BOARD ACTION REPORT – APPEALABLE ITEM

Project Name: 215 NE 1st Avenue
Project Location: 215 NE 1st Avenue
Request: Certificate of Appropriateness, Class III Site Plan, Landscape Plan, Elevations & Variance - 2016-178 & 2017-304
Board: Historic Preservation Board
Meeting Date: June 19, 2019

HISTORIC PRESERVATION BOARD STAFF REPORT

Meeting: June 19, 2019	File No.: 2016-178 & 2017-304	Application Type: Certificate of Appropriateness, Class III Site Plan, Landscape Plan, Elevations and Variances
-------------------------------	--------------------------------------	--

SITE PLAN NOTED

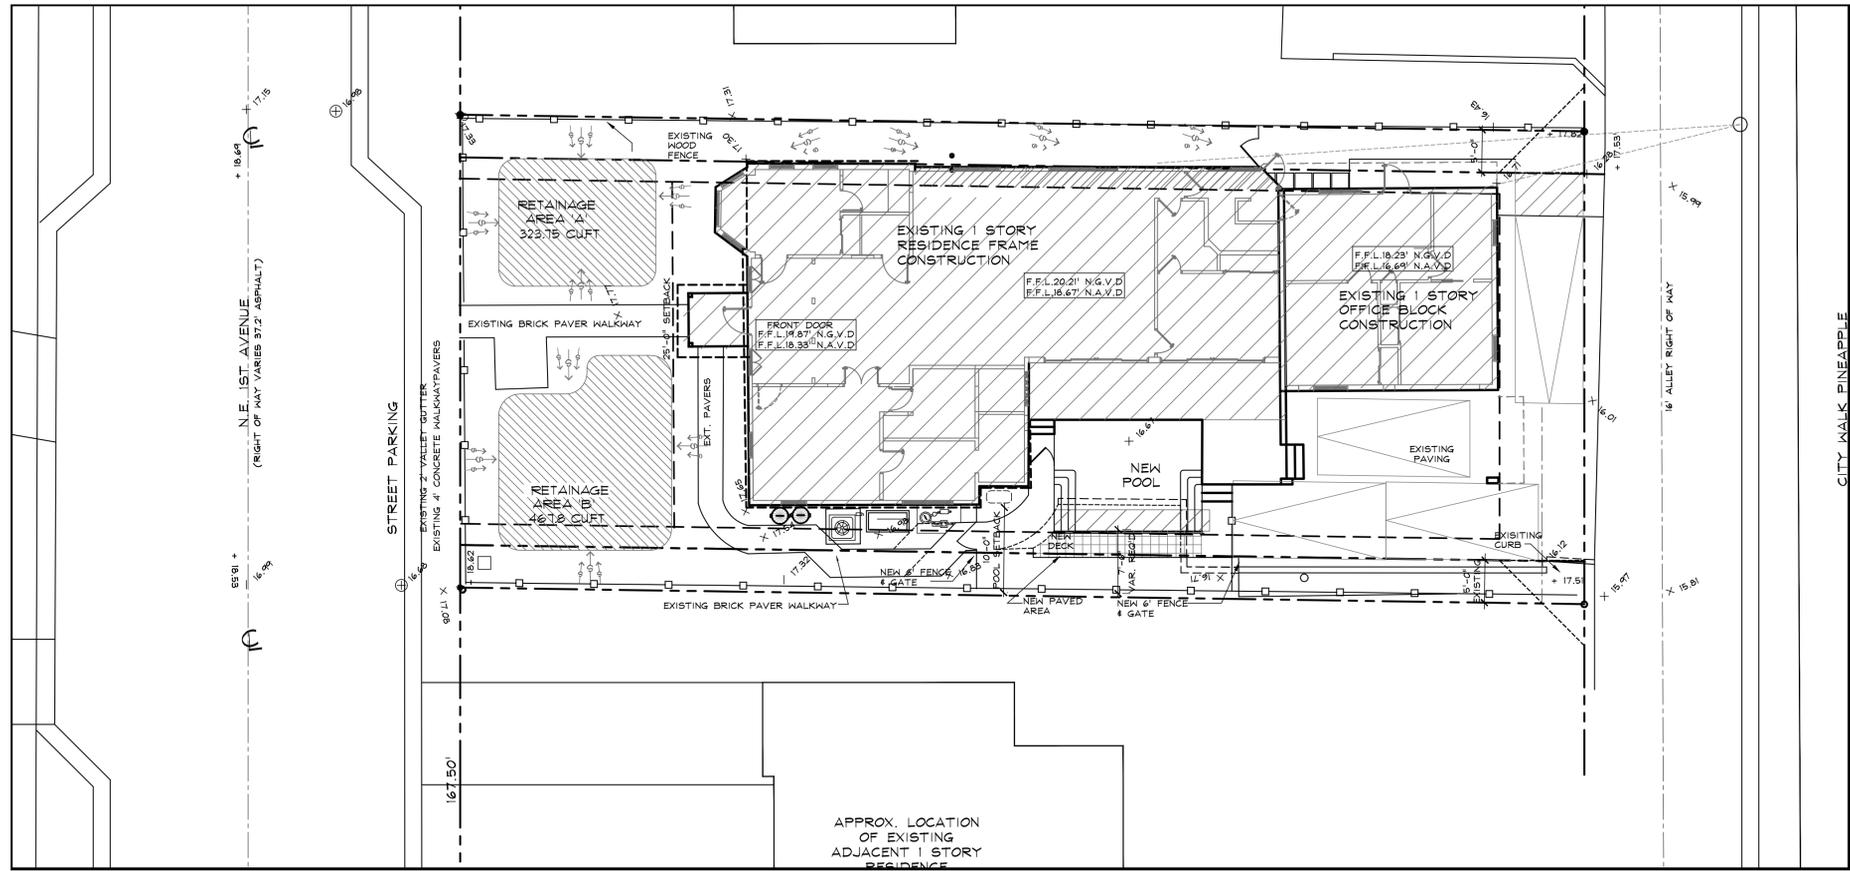
A refuse container area has not been identified on the plans. An added condition of approval is that a refuse container area be noted on the plans and that the area be enclosed on 3 sides with vision obscuring gates on the 4th side.

SHEET
A02

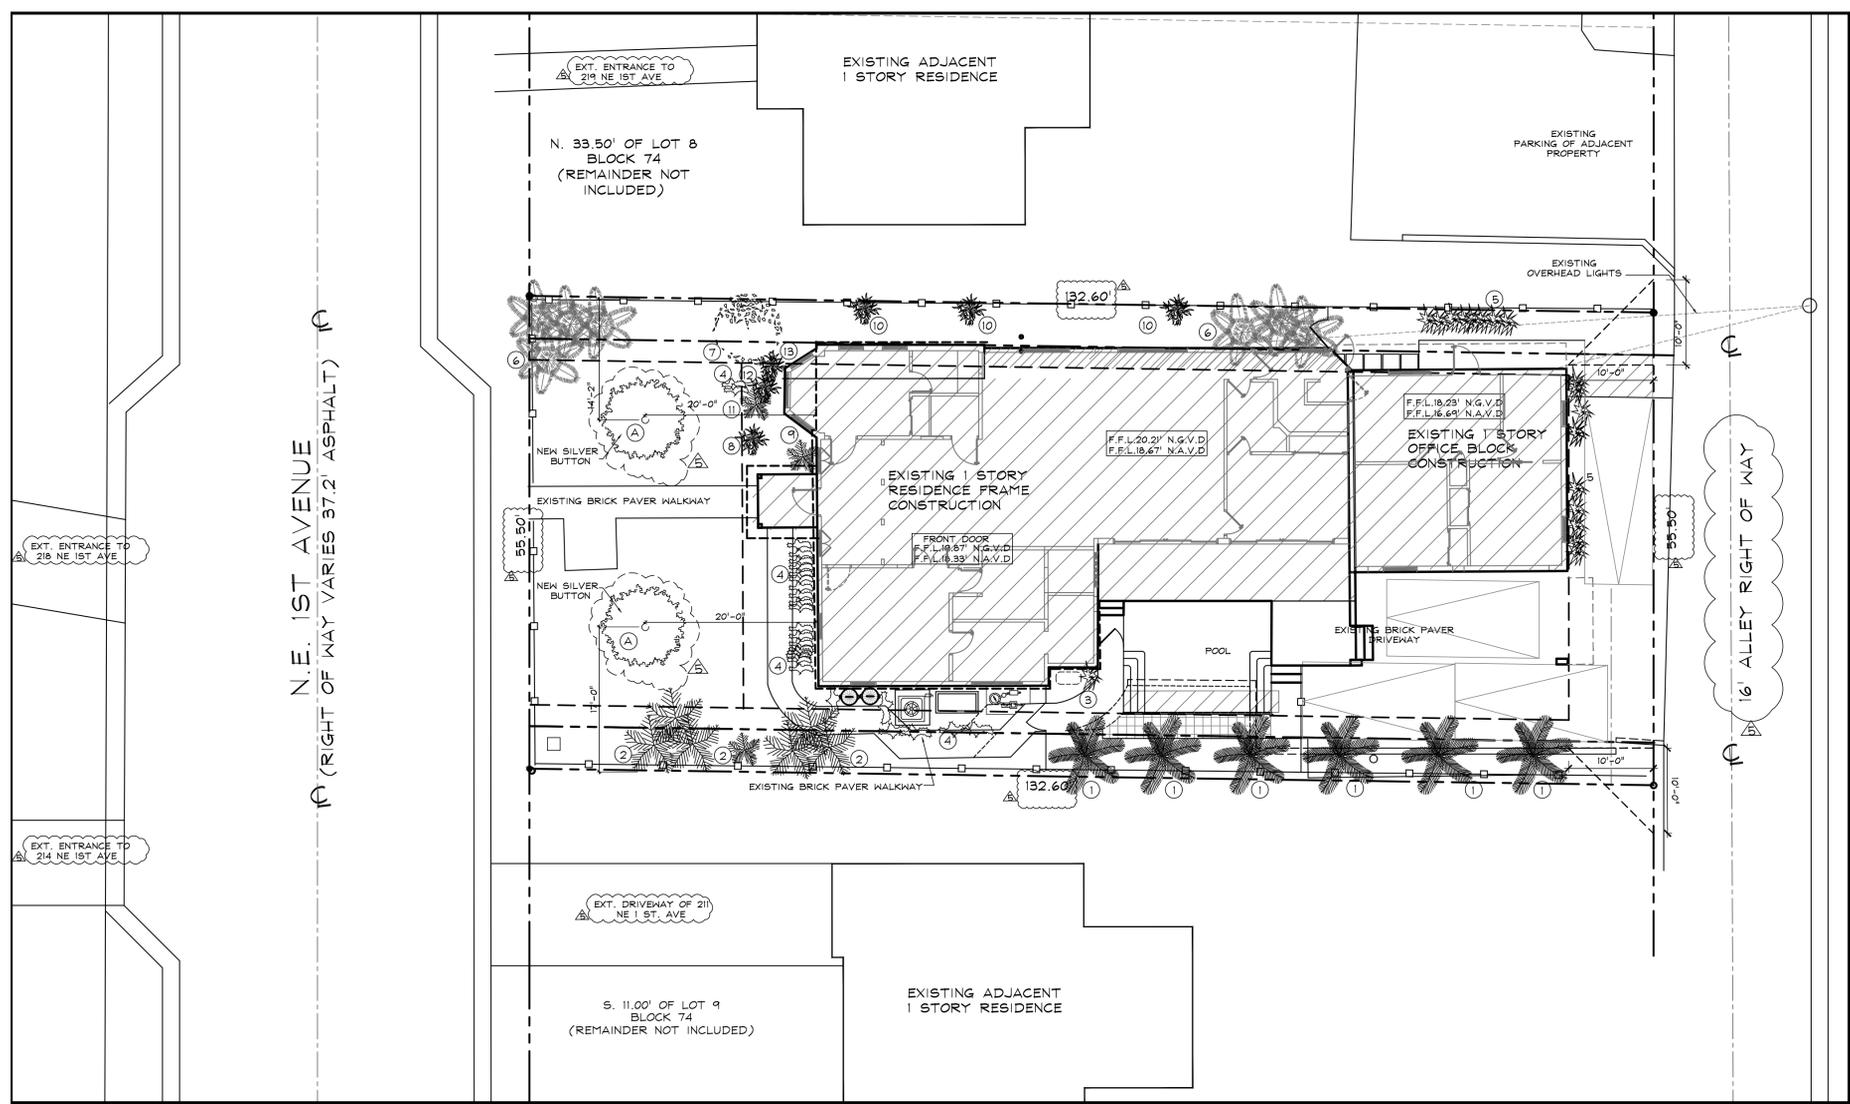
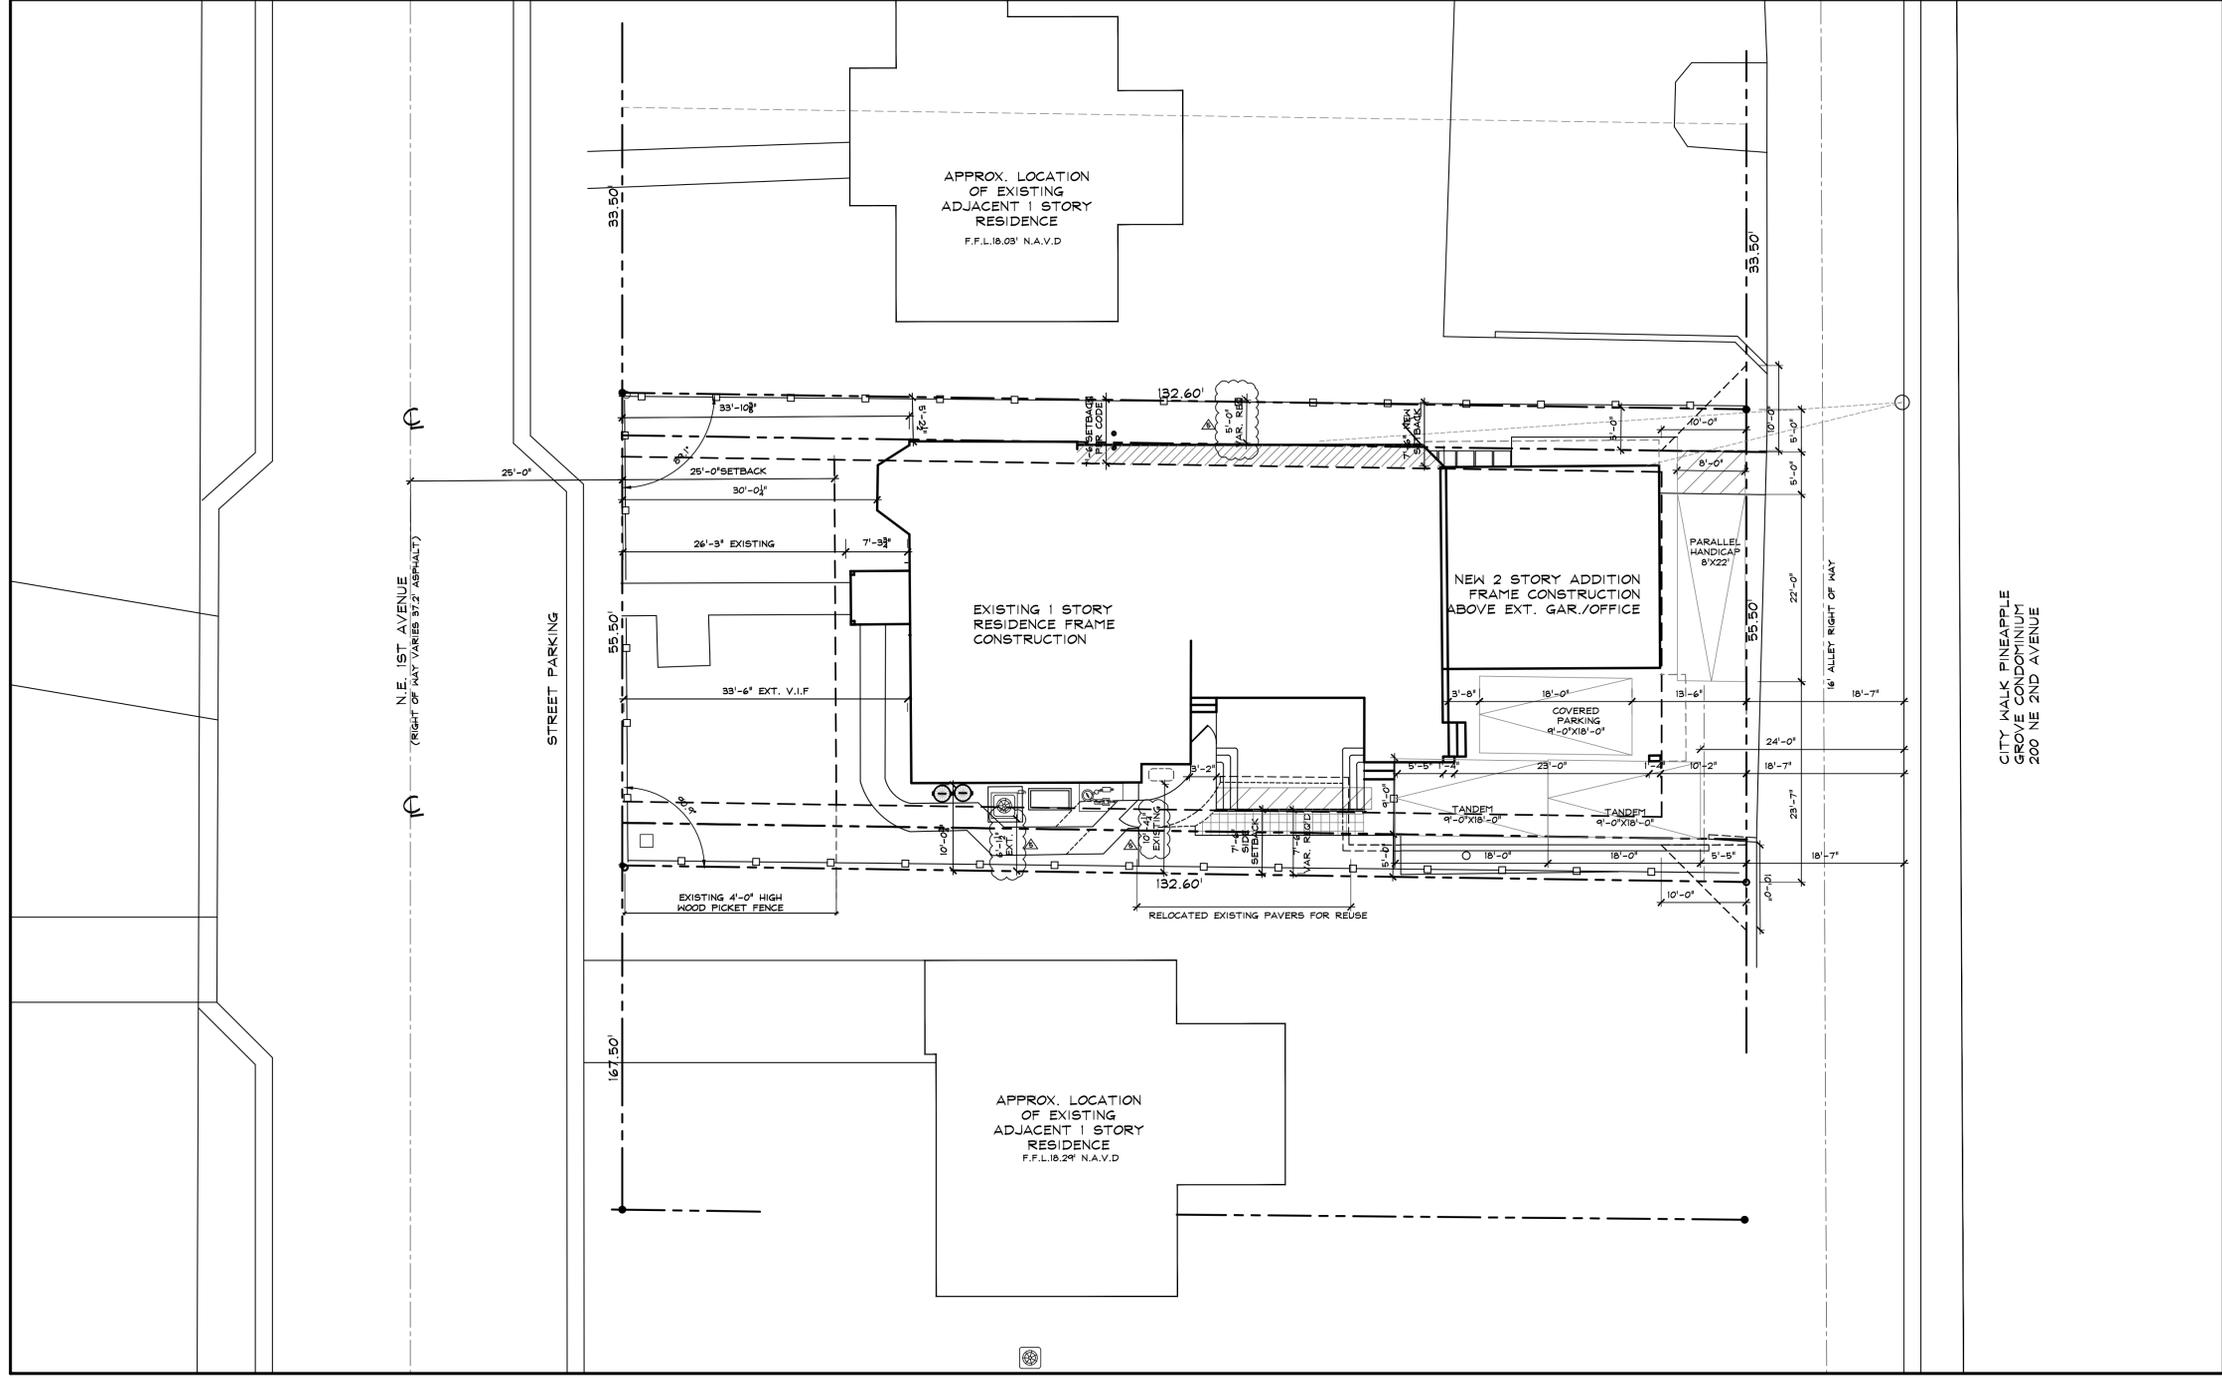
3. That the Landscape Plan be revised to indicate the locational numbers for existing plant material;
 4. That shutter dogs be incorporated for use on all windows with shutters and a note to such be provide on the elevation plan sheets;
